NORTH WITNEY HOUSING DEVELOPMENT

Challenges and Interventions

(Issue 3 – Feb 2025)

Witney Infrastructure Neighbourhood Group (WING)
Feb 2025

Figure 8.1: Recommended Option Concept Design
Pell Frischmann

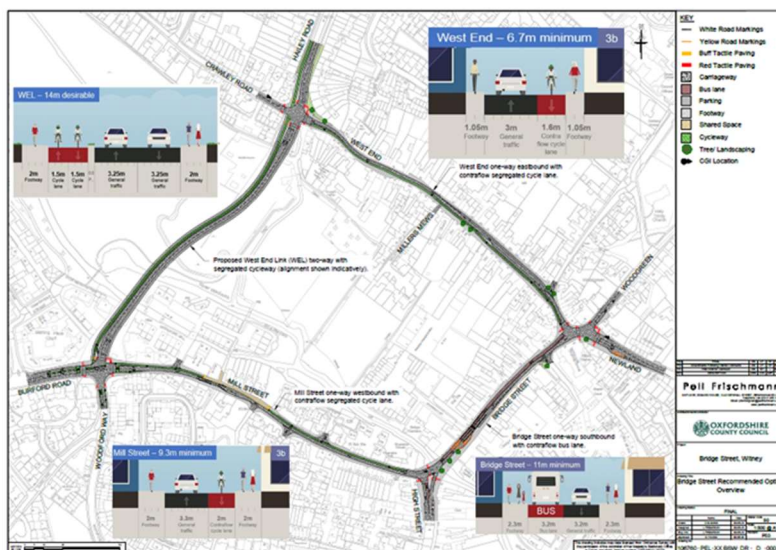
OCC's preferred option for the Bridge Street area of Witney shows the WEL with a carriageway width of 14m. Footways and cycleways make up 7m of this width. If the developers agree to contribute to the cost of the WEL, they will most likely dispute the need for such a wide structure

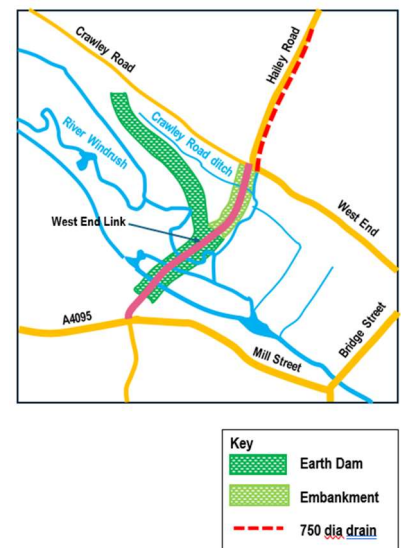
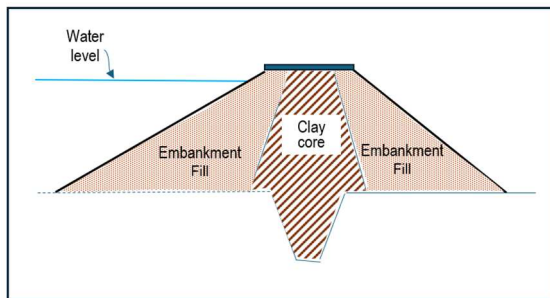
- Overcome the problem with the Crawley Road ditch by changing the shape of the embankment/dam. All three options for the WEL that were considered in the Level 2 SFRA were for a ‘linear’ plan arrangement from high ground on the southern side of the river across to the junction of the WEL with the Hailey Road on the northern side. However, Hailey Road runs down a valley as it approaches the river so the proposed northern end of the WEL embankment in the Level 2 SFRA options was at a relatively low level. The northern end of the dam could be brought round to higher ground to the west of the Crawley Road ditch. This would separate the ditch from the river and allow more water to be retained in the flood plain. This “Y” plan arrangement is illustrated here.

In the diagram above, the earth dam is shown as a dark green shaded strip. Typically, an earth dam is comprised of a clay central core supported by embankment fill. The clay prevents seepage through the dam and extends down in a trench to prevent seepage under the dam. It is possible that the material for construction could be sourced from the flood plain although a full ground investigation will be needed to confirm this. If suitable earthworks materials are found, there are significant benefits:

Current arrangement

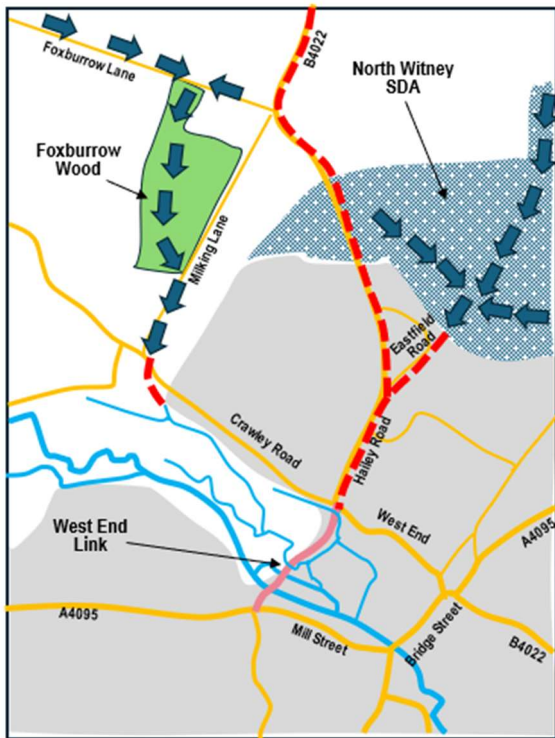
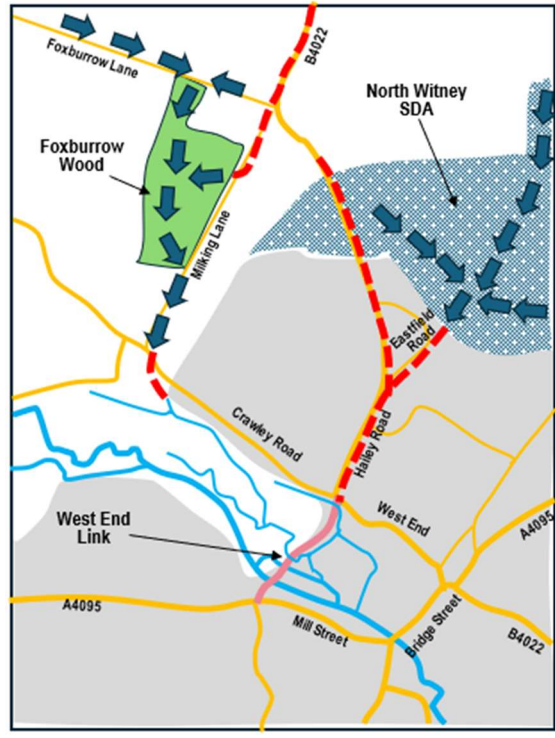
The 750mm diameter drain from the junction of Eastfield Road with Hailey Road down to the outfall into the basin area above Bridge Street is the focus for this table. Currently this length of piped drain becomes overloaded in periods of severe rainfall and overflows from the manholes onto the road surface. The outfall from the drain into the basin is also restricted because the basin is in flood. Consequently, more water backs up in the drain. The roundabout at the bottom of Hailey Road becomes flooded and impassable.

Intervention Number	Description	Outcome/Comment
Interventions downstream of Hailey Road Drain		
HR1	Clear the obstructions and flooding issues downstream of Hailey Road to ensure there is a clear outfall into the basin.	This target should be achieved through completion of the Bridge Street interventions 1-6 as listed in the table above.

Intervention Number	Description	Outcome/Comment
Interventions at Hailey Road Drain		
HR2	Consider measures to increase the capacity of the drain.	A complete reconstruction of this drain would be expensive and extremely disruptive. WING’s proposal is that this action could not be justified.
Interventions upstream of Hailey Road Drain		
HR3 (linked to Bridge St Intervention No.7)	Reduce the peak flow entering the Hailey Road drain from North Witney housing area by constructing attenuation ponds in the development area.	A series of small attenuation ponds is indicated in the developer’s proposals for North Witney housing. Although these may be adequate to limit the flow rate from the housing development into the existing piped drainage system and prevent an increase in flow, these proposals will not overcome the current flooding problems in the Hailey Road drain. Providing fewer, larger ponds to increase capacity would reduce flood risks for Witney. The current drainage arrangement floods during severe weather events. An element of improvement is therefore essential.
